# PLANNING DIVISION STAFF REPORT

November 7, 2022

**Project Address:** 6706-6714 Odana Road

**Application Type:** Demolition Permit, Conditional Use, & Certified Survey Map Referral

Image 1: A portion of the Odana Area Plan’s [Path, Pedestrian, and Bicycle Network Improvements Map](#). (The subject site is highlighted)

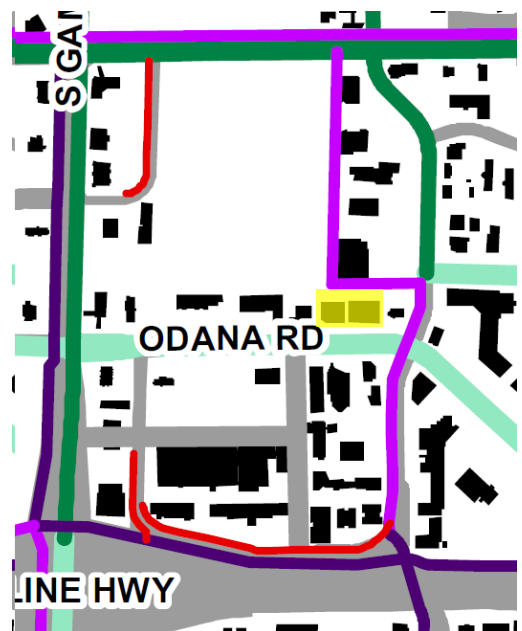
The [Odana Area Plan](#) also recommends a Planned Off-Street Path be constructed along the subject site’s northern property boundary. It will become part of the path which is planned to start at the bend in Grand Canyon Drive adjacent the Beltline, run along Grand Canyon Drive, jog west along the northern edge of the subject parcel, turn north near the northwest corner of the subject parcel, and continue up to the intersection with Mineral Point Road. (The path is shown in the fuchsia-colored line running north-south in the image to the right. The subject parcel is highlighted yellow.) To this end, as easement widths are typically 20’ wide for paths, since the path will straddle the property line, agencies have recommended the

applicant grant a 10-foot-wide easement for the pedestrian and public path along their northern lot line. Note: staff met with the applicant shortly before completion of this staff report to discuss possible forthcoming site plan modifications to accommodate this easement. A condition of approval has been added to this report, noting a revised site plan will be required for full staff approval to accommodate this recommended easement.

1. The applicant shall submit revised plans accommodating the 10-foot property line along the northern property line. These shall be reviewed and approved by City Agencies prior to final signoff.
